RFQ NUMBER
 RMA10031

LINE	QUANTITY	UOP	CAT NO	ITEM NUMBER	UNIT PRICE	AMOUNT
				ADDENDUM NO. 5		
				THIS ADDENDUM IS ISSUED TO:		
				1.) ANSWER ALL TECHNICAL QUESTIONS SUBMITTED IN ACCORDANCE WITH THE PROVISIONS OF RFQ RMA10031,		
				2.) PROVIDE ADDITIONAL DRAWINGS PER ATTACHMENT A,		
				3.) PROVIDE ADDITIONAL SPECIFICATIONS PER ATTACHMENT B, AND		
				4.) PROVIDE A COPY OF THE MANDATORY PRE-BID ATTENDEE LIST.		
				BID OPENING DATE REMAINS: 08/17/2010		
				BID OPENING TIME REMAINS: 1:30 PM		
				***** END ADDENDUM NO. 5 *****		
0001	1	LS		570-48		
				RAIL REPLACEMENT

RE: Addendum #4 to RFQ #RMA10031 – Rail Replacement on SBVR

Attachment A - Page 1 of 2

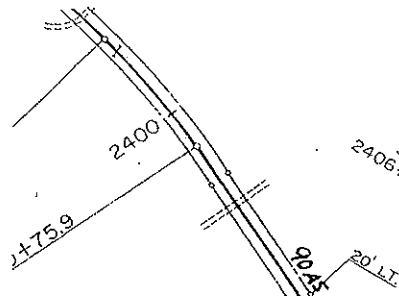
1. Track Charts: Project locations and other information are provided on the attached track charts (Attachment A).
2. Tie Spacing: Average tie spacing shall be 20" for estimating tie plates, tie plugs, spikes and rail anchors.

12. Work Train: SBVR can provide a work train consisting of one locomotive with engineer and two flat cars for \$125.00 per hour.
13. Welded Rail: The 131/132RE rail installed at the south end of Moorefield Yard will be welded and installed in accordance with AREMA specifications and the SBVR CWR Program (Attachment B). Rails will have bolt holes removed by cutting the rail ends with a rail saw. Rails will be welded straight and then placed in curves. The quality of all welds shall be checked by the contractor using magnetic particle or ultrasound inspection in accordance with AREMA specifications. Test results are to be provided to the SBVR. The south end of this section shall comp down from 131RE to 105DY to 100RB.
